CITY OF ALBUQUERQUE

Re: N-Demand Expansion
3801 Academy Parkway South NE
Traffic Circulation Layout
Engineer's Stamp 2-14-2022 (E17-D001J)

Based upon the information provided in your submittal received 01-03-2022, the above referenced plan cannot be approved for Building Permit until the following comments are addressed:

TRAFFIC CIRCULATION PLAN

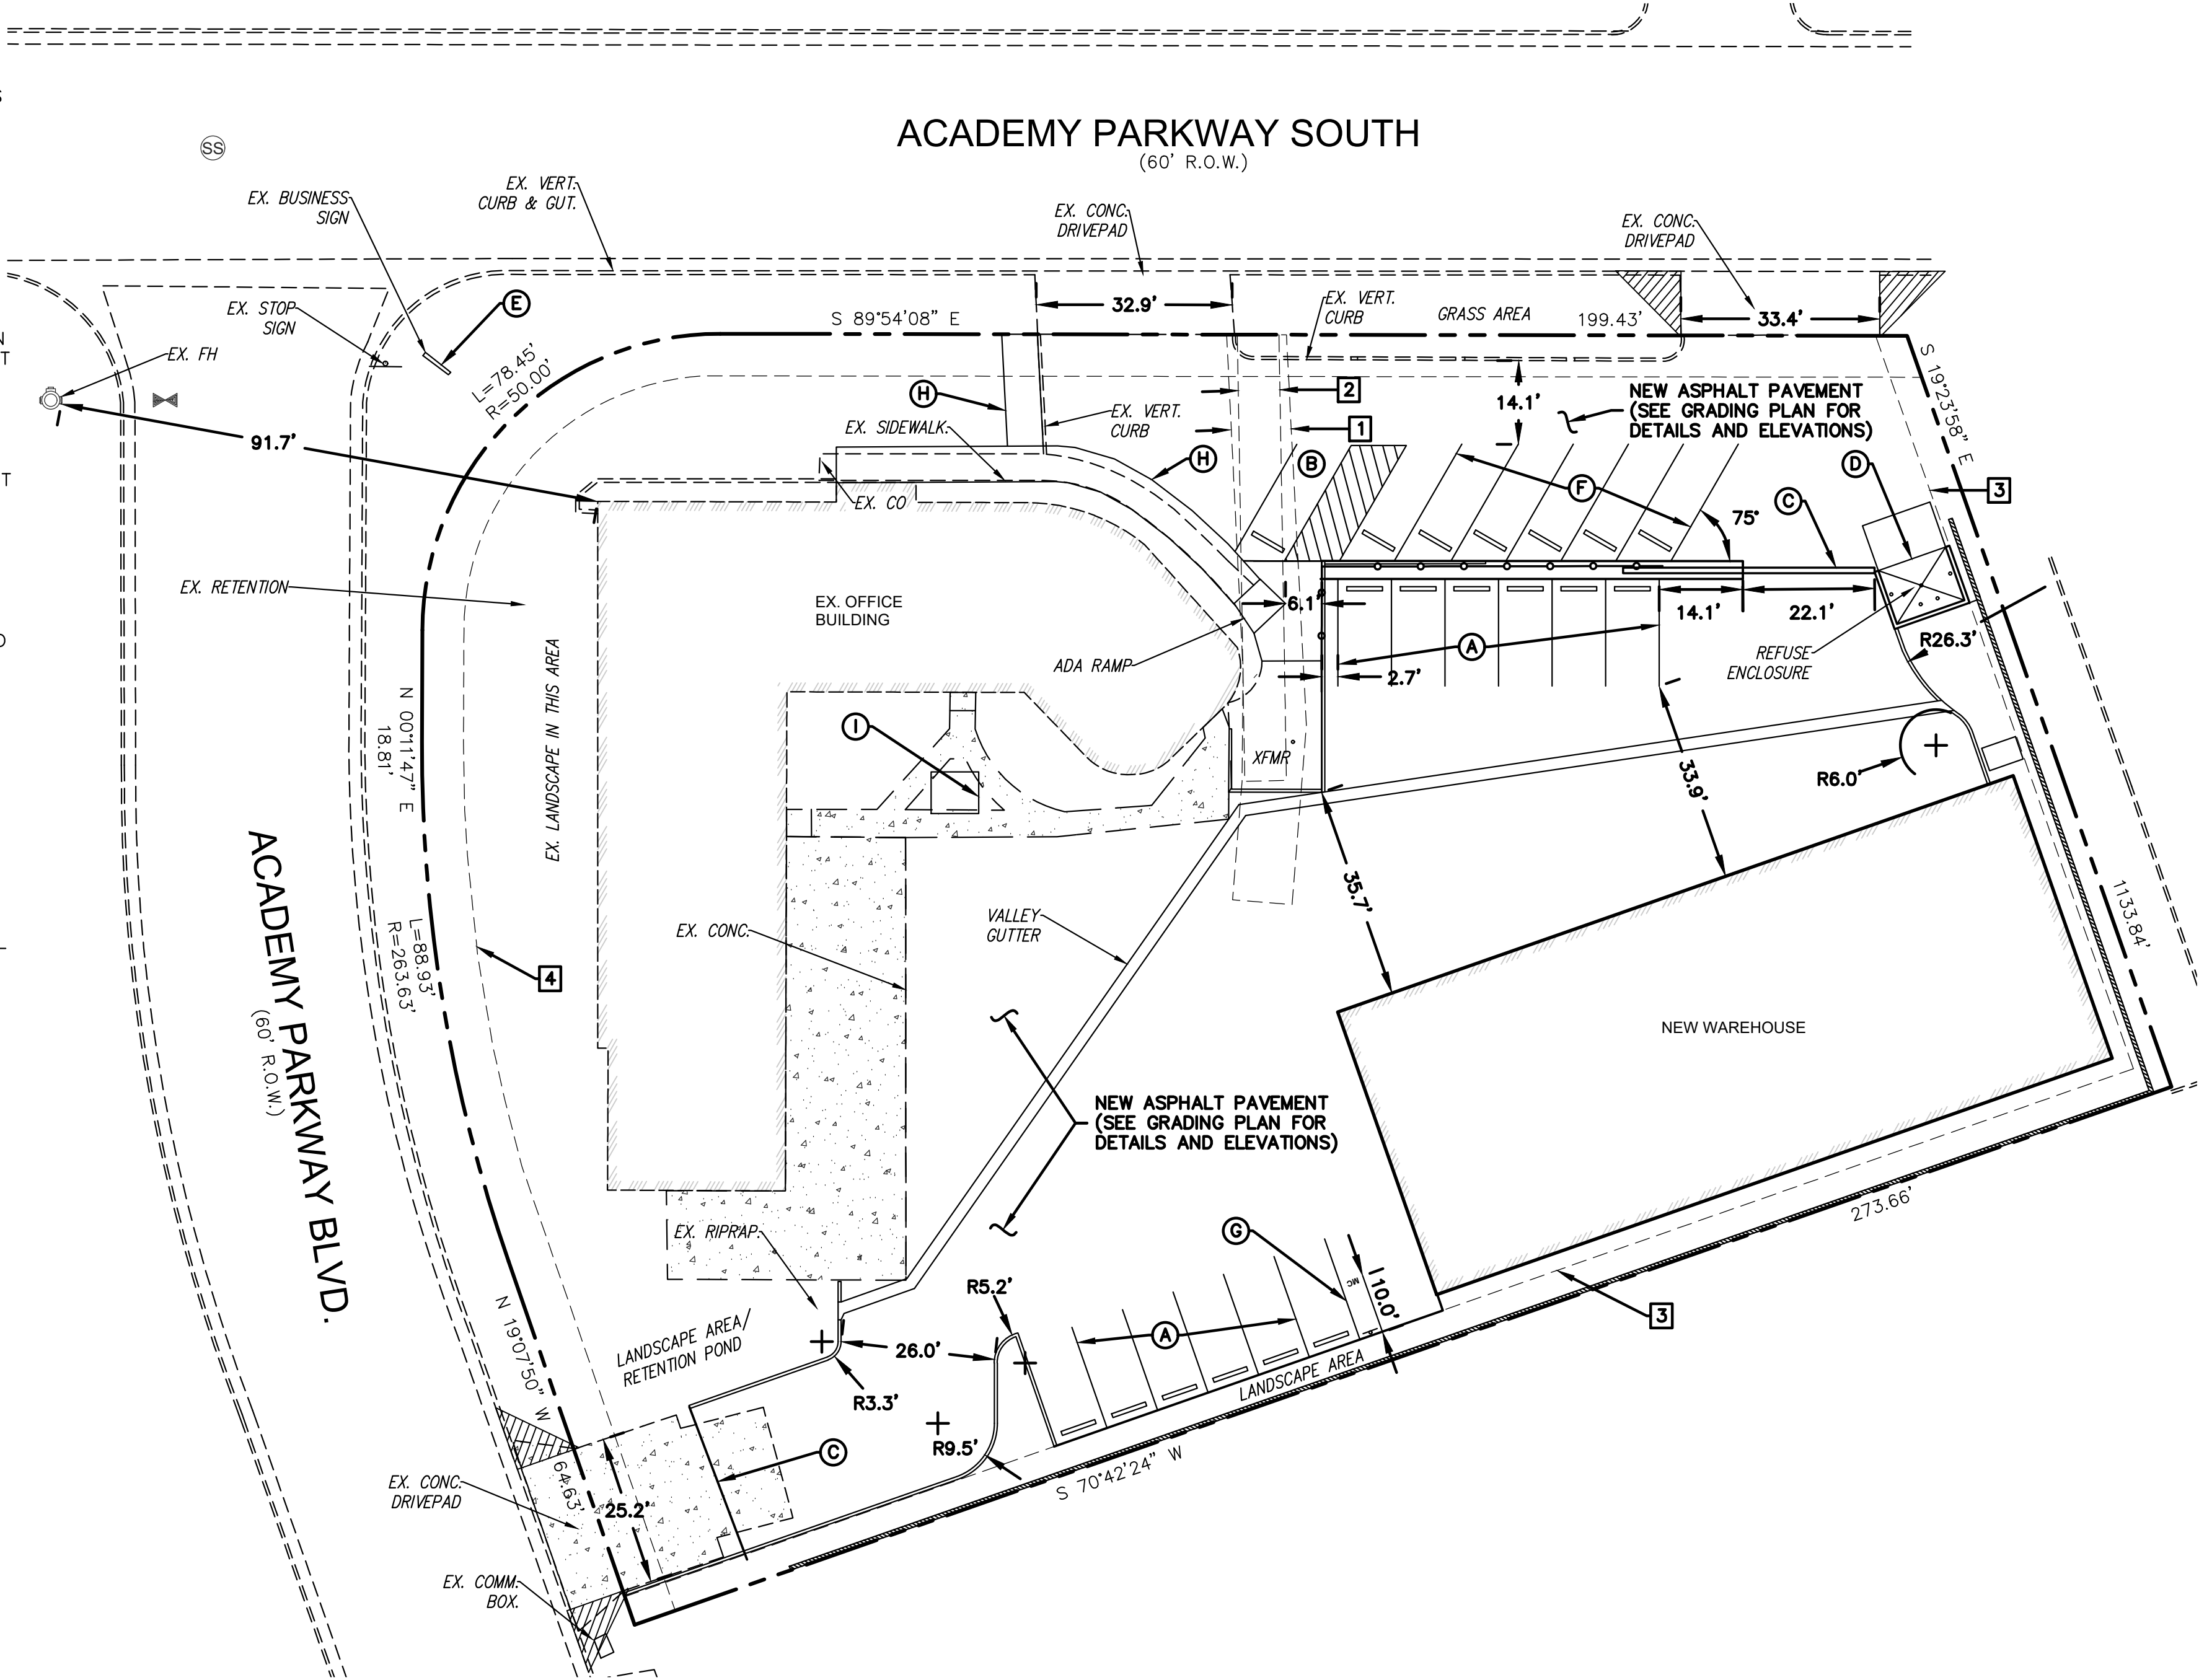
1. Listed all the number of Motorcycle parking spaces and Bicycle Racks required by the IDO.
2. Angle parking: drive aisle width should be 22 ft. Suggestion: change the angle of the parking stall to 60 degree. See the table below

4. Provide on-site ADA ramp's details.
5. South-west Entrance: Provide signs indicates that this entrance for employees only. Show the location of the sign on site plan.
6. Provide a copy of Fire Marshal Approval.
7. Provide a copy of Sidewalk Variance.
8. Please show clear site triangle at the North side existing drivepad. and add the following note to the plan: "Landscaping and signage will not interfere with clear sight requirements. Therefore, signs, walls, trees, and shrubbery between 3 and 8 feet tall (as measured from the gutter pan) will not be acceptable in the clear sight triangle.
9. Please specify the City Standard Drawing Number when applicable.
10. Please provide a letter of response for all comments given.

- F. STRIPE 75° ANGLE PARKING AREA AS SHOWN ON PLAN. PROVIDE L=20.3', W=8.8' D=19.6'. USE 4" WHITE PAVEMENT PAINT, AND PROVIDE PARKING BUMPER IN EACH STALL PER DETAIL 2.

- G. PROVIDE 4' WIDE MOTORCYCLE PARKING SPACE WITH SIGN PER DETAIL 3. THIS SHEET, AND WITH "MC" (12"HX2"W WHITE LETTERING) PAVEMENT MARKING.
- H. WIDEN EXISTING SIDEWALK TO PROVIDE 6' FOR ADA PATH. OR CONSTRUCT NEW 6' WIDE SIDEWALK WHERE NECESSARY. SIDEWALK TO BE 4" THICK CONCRETE WITH WIRE MESH REINFORCING. PROVIDE NEW ADA RAMP WITH 8% MAX. SLOPE AS SHOWN ON PLAN.

- I. INSTALL BICYCLE PARKING PER DETAIL 4, AND AT LOCATION SHOWN ON PLAN. PROVIDE 4" THICK CONCRETE WITH WIRE MESH REINFORCING, MATCH EXISTING CONCRETE ELEVATION.
